# Authorized Field Change

**AFC 14906**
**Date:** October 2014

**Subject:** Clutch Switch Inspection and Replacement.

Model: LoneStar<sup>®</sup>, ProStar<sup>®</sup>, and TranStar<sup>®</sup>  
 Start Date: 01 March 2013 End Date: 04 February 2014

**Figure 1. Clutch Switch Inspection.**

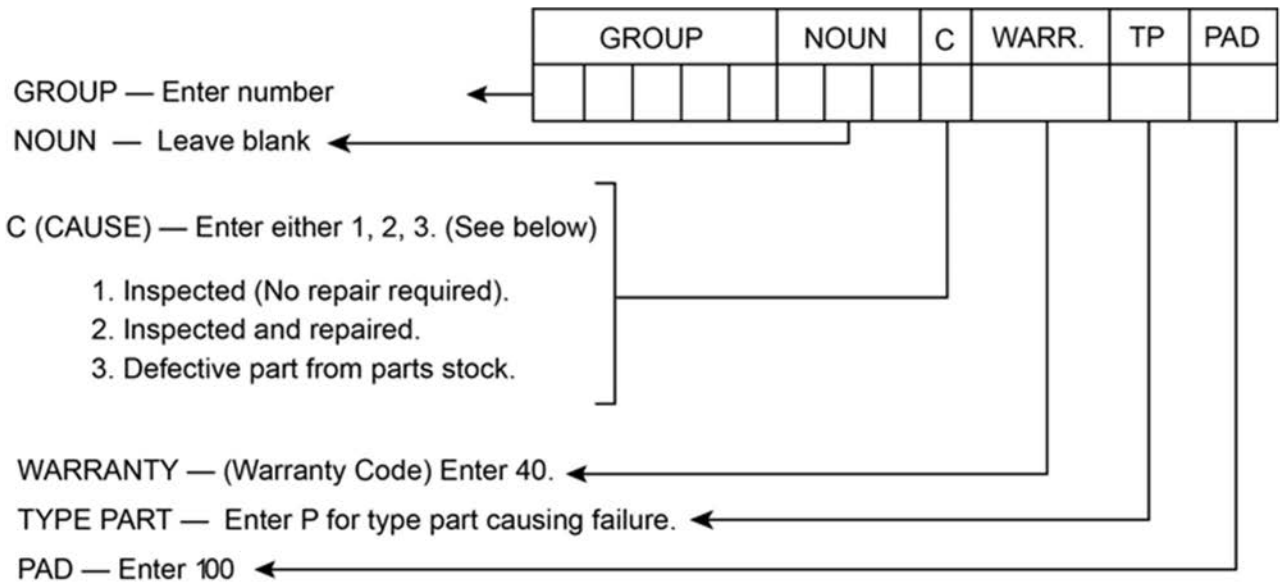
1. Clutch switch
4. Inspect clutch switch (Figure 1, Item 1) color.
    - a. If clutch switch (Figure 1, Item 1) is black, install new clutch switch.

- b. If clutch switch (Figure 1, Item 1) is not black, clutch switch does not need to be replaced.
5. Replace master cylinder, if vehicle was built between 04 November 2013 and 04 February 2014 at Escobedo, or between 20 December 2013 and 04 February 2014 at Springfield. Refer to [Service Manual Section, Hydraulic Clutch Service Manual, S11018](#).
6. Verify clutch switch operation by depressing clutch pedal to crank vehicle. Starter should engage in a range from a little before to just after clutch brake contact, which is indicated by pedal coming to a stop with same amount of effort being applied to clutch release pedal as was used to stroke clutch release pedal.
7. Install two modesty panels onto vehicle with one M6 x 35 mm bolt, one M8 x 45 mm bolt, and 11 screws.
8. Remove wheel chocks.
